OPEN
Compute Project

OCP NIC 3.0 Design Specification

Version ~~0.50~~1

Author: OCP Server Workgroup, OCP NIC subgroup

Figure 5: Example Large Card Form Factor

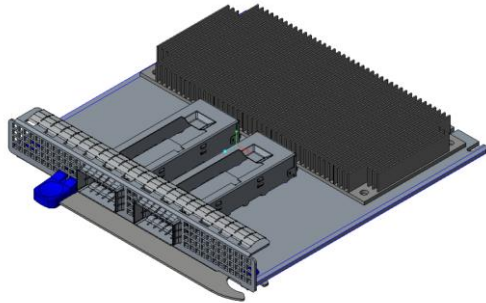
Commented [HS2]: For some use cases, secondary connector is not required to be used for large card size. We need to discuss and clarify it.

Commented [JN3]: If so, I think we still need the 2C+OCP card edge GF drawing.

Figure 50-23: Scan Bus Connection Example

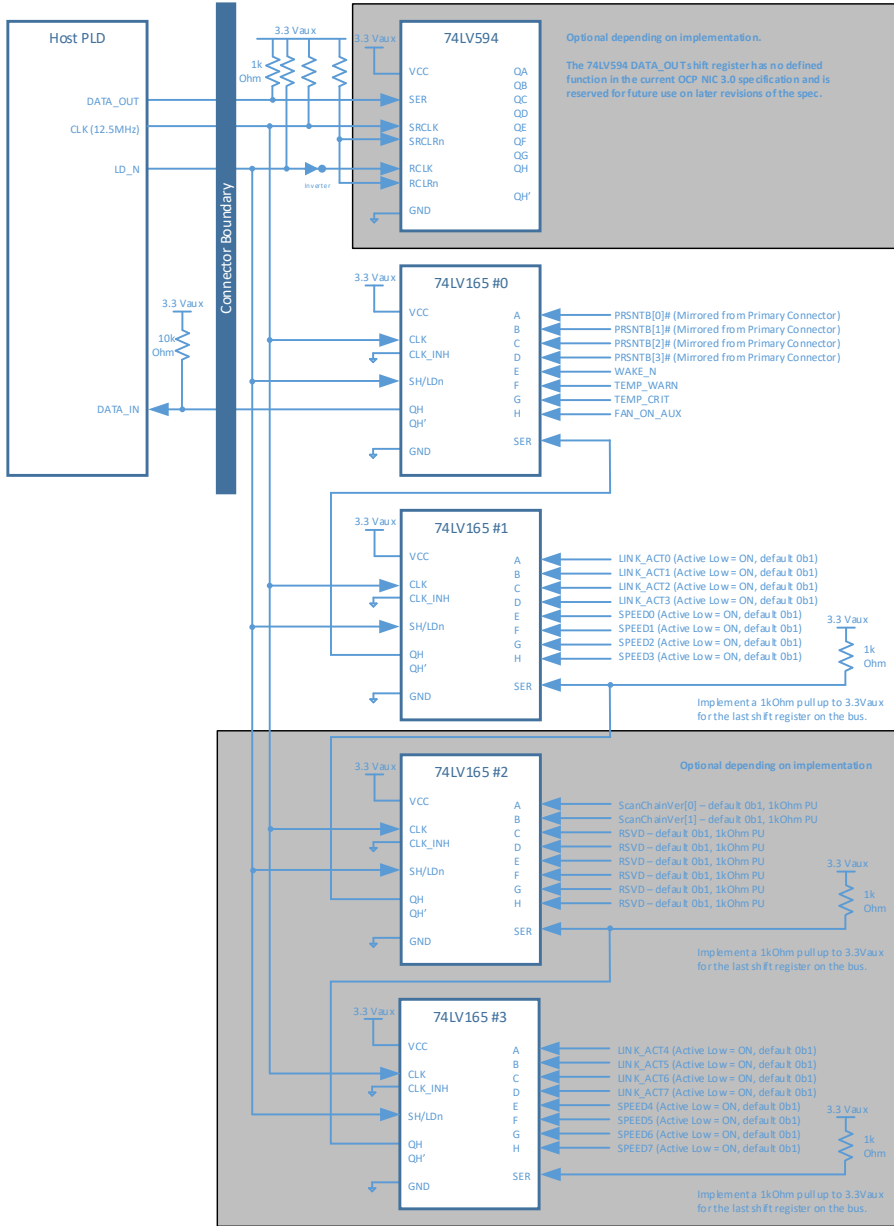
Commented [TN14]: Need to discuss this (see Hamel's comment in prior sections regarding making the scan chain mandatory on the AIC)

Figure 34: Block Diagram for Emulated Thermal Reporting

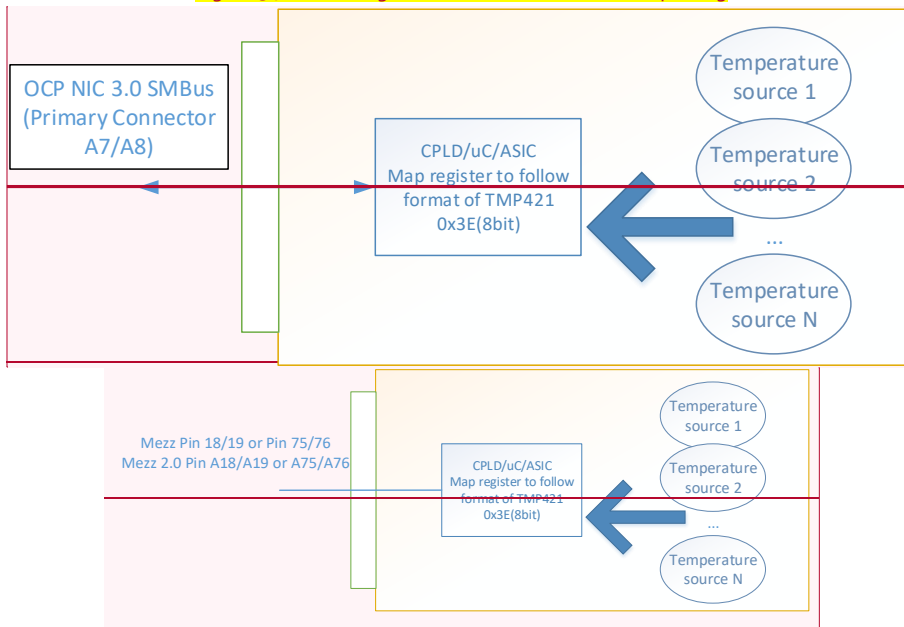
Commented [JN38]: Needs update

Figure 6135: Block Diagram for Remote on-die Sensing

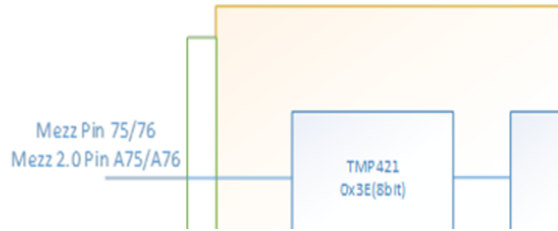
Commented [JN40]: Update pin # of diagram
